MUNICIPAL ENGINEER'S OFFICE,

NOTICE UNDER SECTION 96 OF ACT III OF 1901.

— PROPOSED ALTERATIONS —

— ALNDALE —

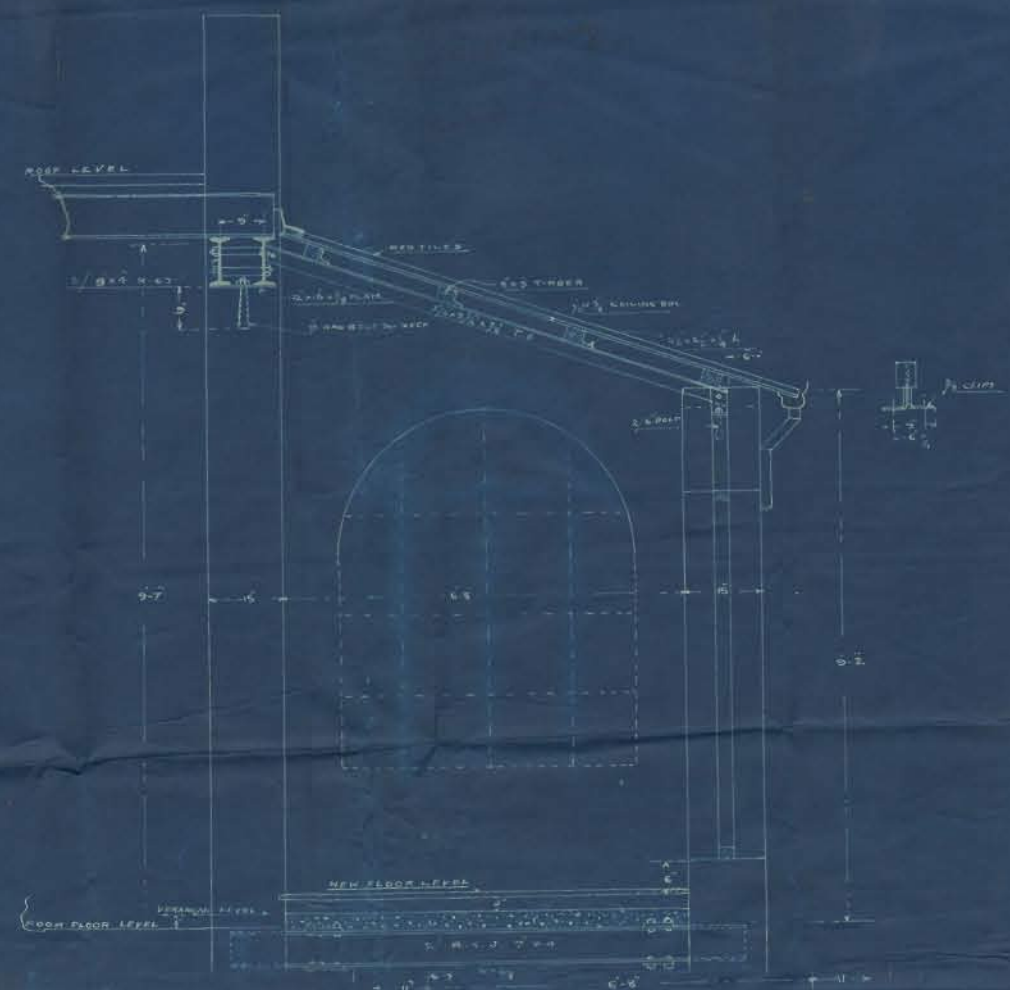
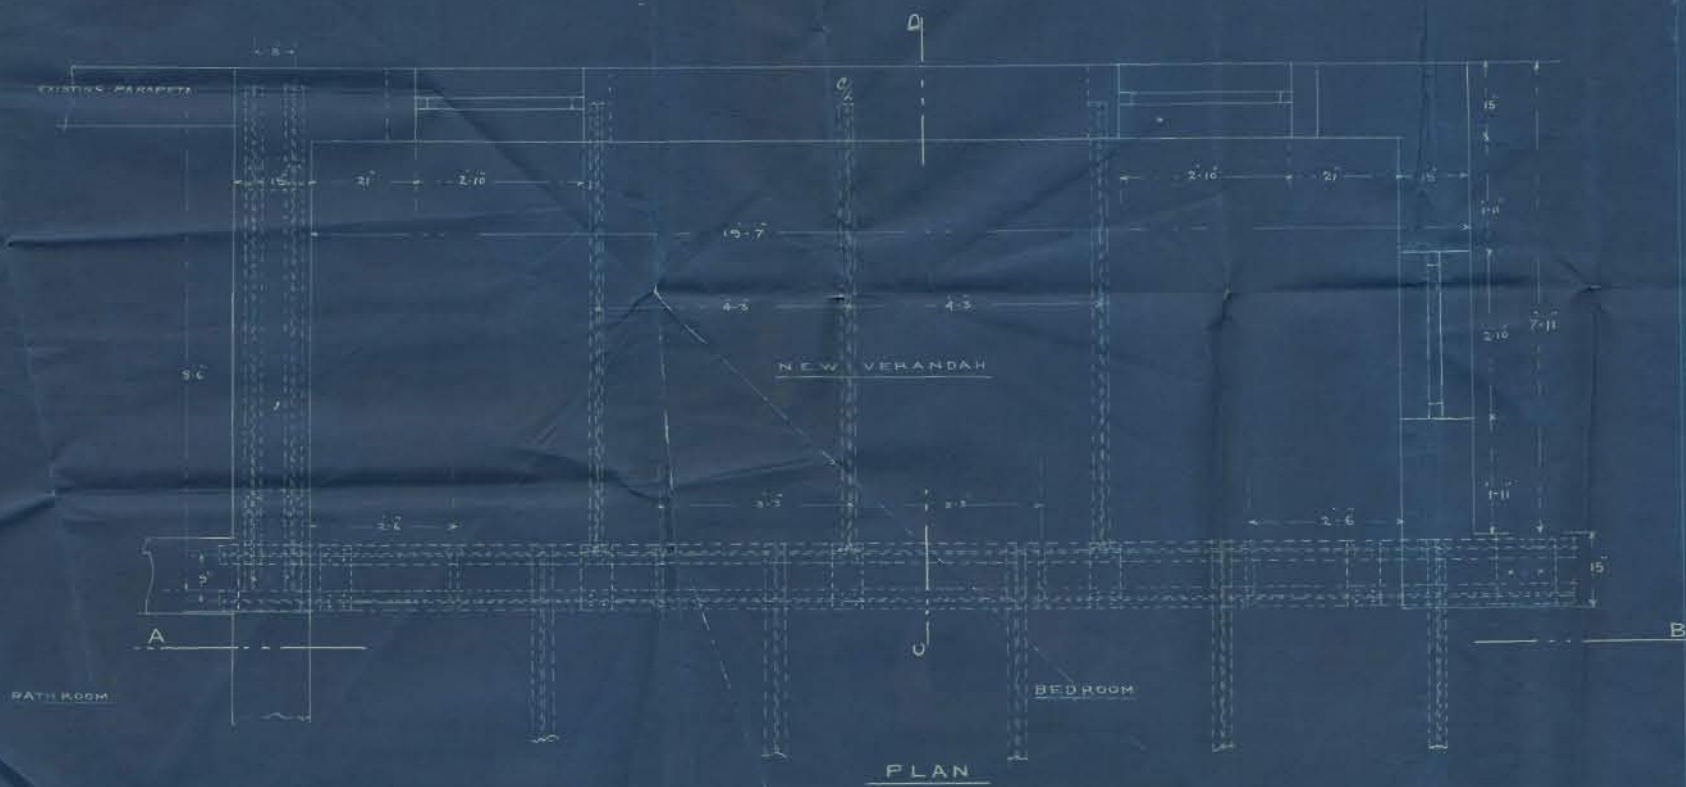
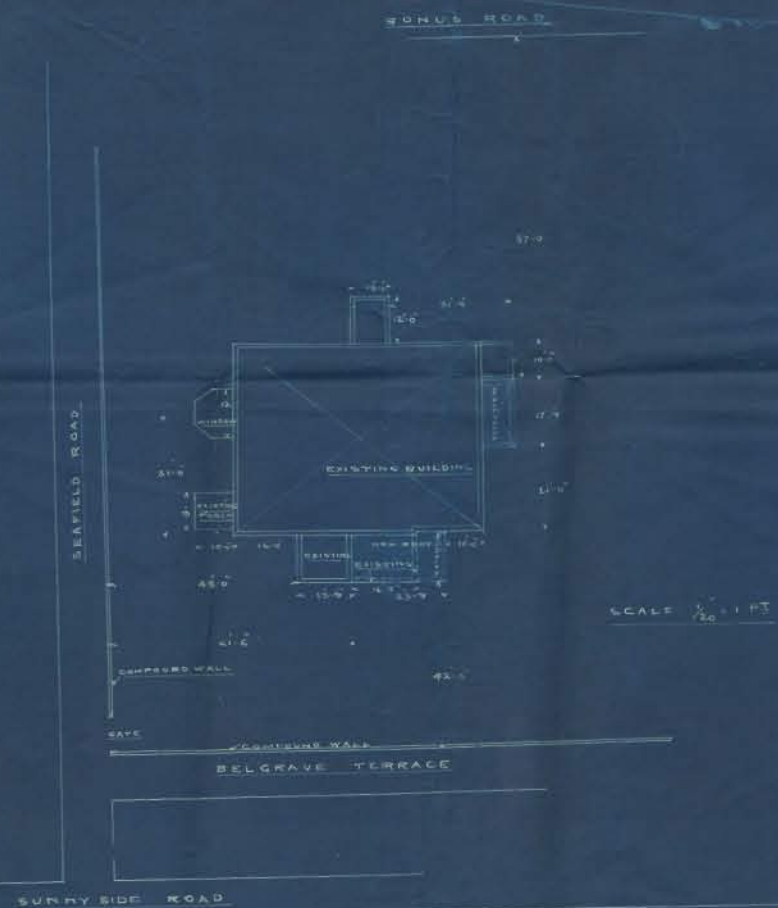
*L. Pinner
Issue Plans
The plans are alright.
23/9/15*

Remarks See with reference to this they to
report that there is no objection to permission
to erect veranda as requested -

PLAN OF PROPOSED HOUSE
ON PLOT N^o 34/A & 34/B SHEET C 6
MARKET Q^o
SCALE 8" = 1"

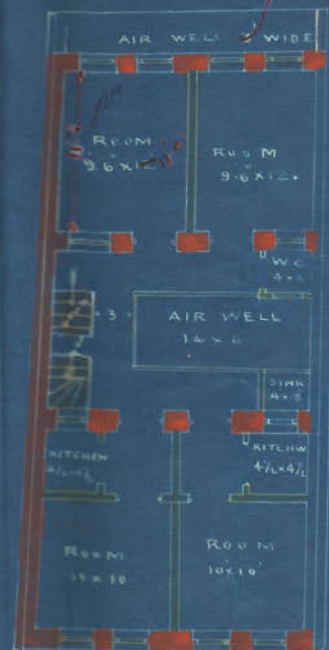
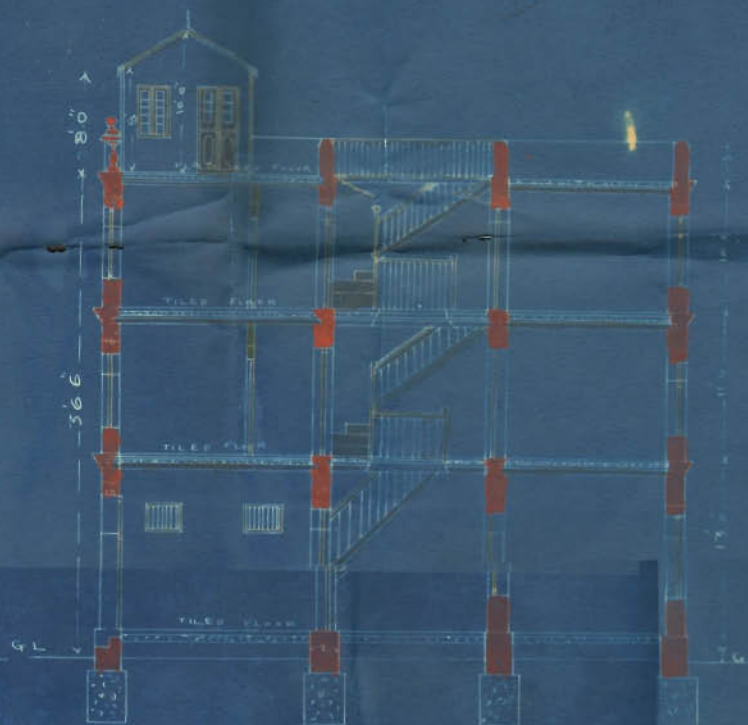
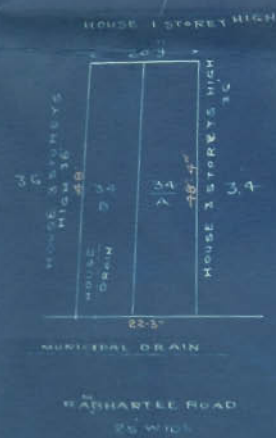
*The pally at the back should be
at least 6' (ft) wide*

Remarks Sir, with reference to this I beg to report
that there is now no objection to permission
to be granted as the alignment has
been set back
17-8-1915

PLAN OF PROPOSED SHOP

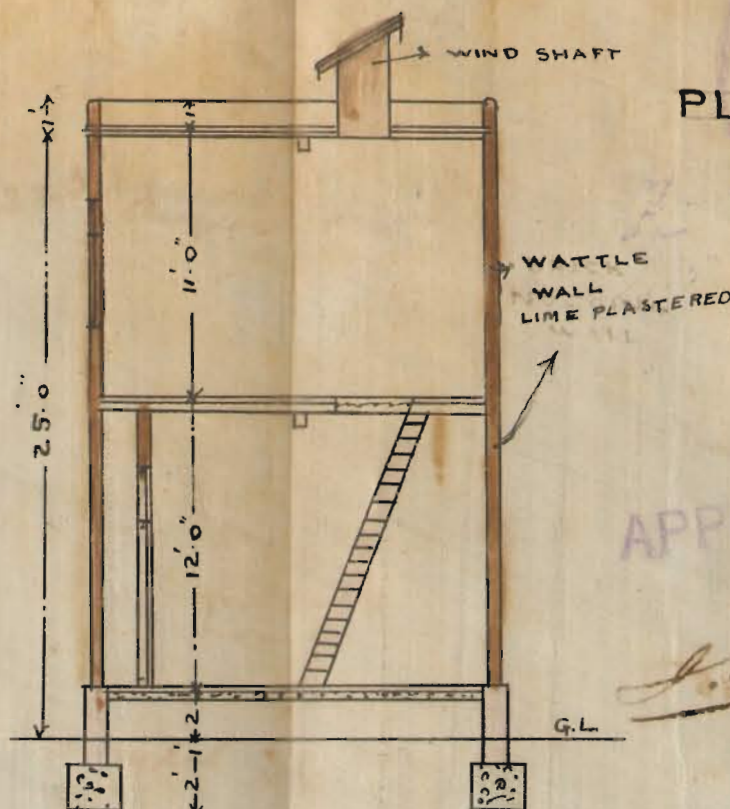
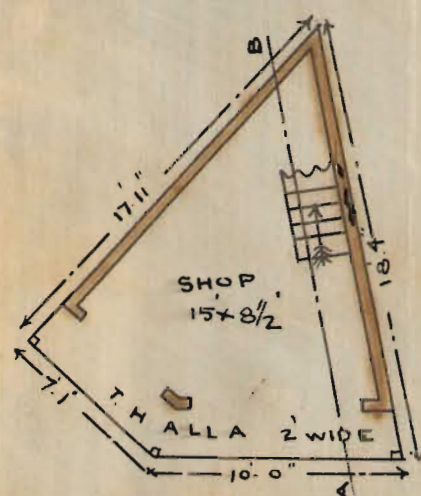
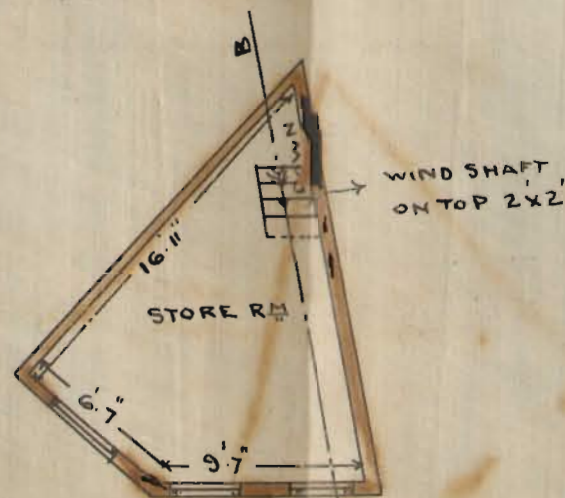
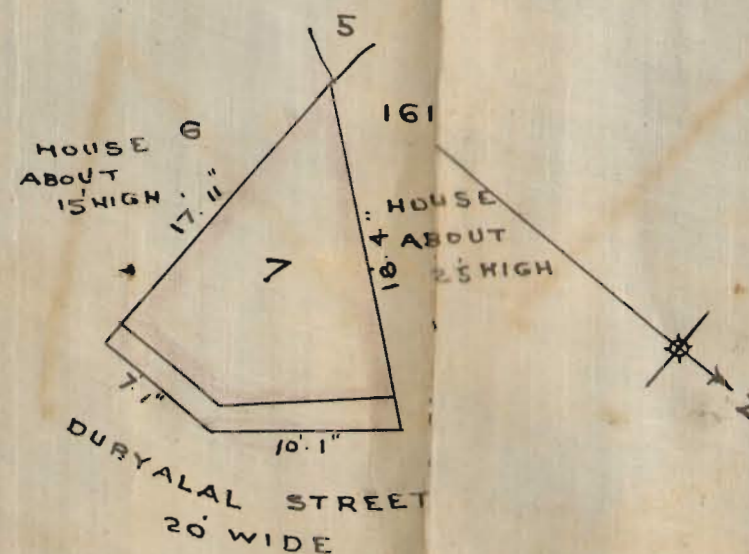
Grant permission subject to the walls being made good & line clear no mud will be allowed.Grant permission
11/8/15
G. Cecil L. Parry
A. M. I. C. E.,
Engineer,
Karachi Municipality.

With reference to his application dated 2nd inst. with a set of plans for building a house on plot No. 7, A-19 Market Quarter Mr: Khushaldas Thakurdas is informed that his plans are approved subject to the walls being made of wood and lime chunam. No mud is to be allowed. He is requested to apply for permission to the City Deputy Collector with two copies of plans returned herewith duly signed and approved. He must not start any building operation until he hears further from this office.

SHOWING PROPOSED BUILDING
ON PLOT No 58, SHEET C.2.
MUCHEE MEANEE QUARTER.
SCALE 4" = 1"

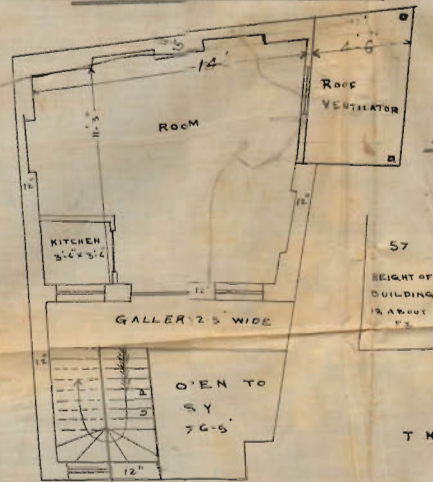
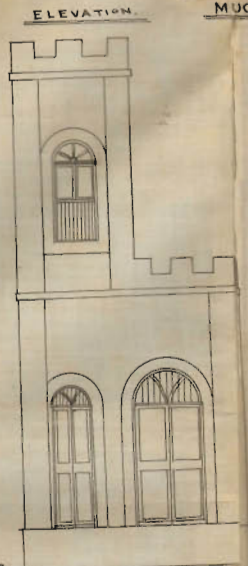
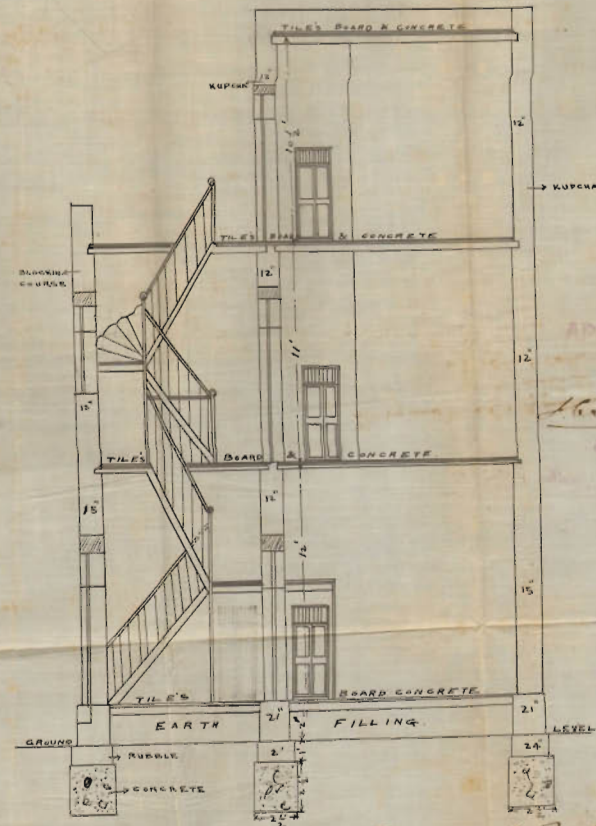
With reference to his application dated 23rd October 1914 with a set of plans for building a two storéed house on plot No. 58, C-2 Muchi Meani Quarter Mr: Kanyalal Hardasmal is informed that the same can not be approved owing to the situation of the W.C. being void of means for foul air to find exit,. The rooms too have no through ventilation. The plans are therefore returned for amendment

With ref. to this appl. D 23/10/14 with
a set of plans for a two-storied house on plot no. 58 C-2 in the
that the same can not be approved owing to the situation
of the W.C. being void of means for foul air to find exit.
The rooms too have no through ventilation. The
plans are therefore returned for amendment.

With reference to your memo: No: E/ 2054 of 1915, I beg to submit herewith an amended plan on plot No: 58, C 2, Muchee Mianee Quarter showing a roof ventilator for through ventilation in the rooms. The water closet is now shown in the open space with proper ventilation.
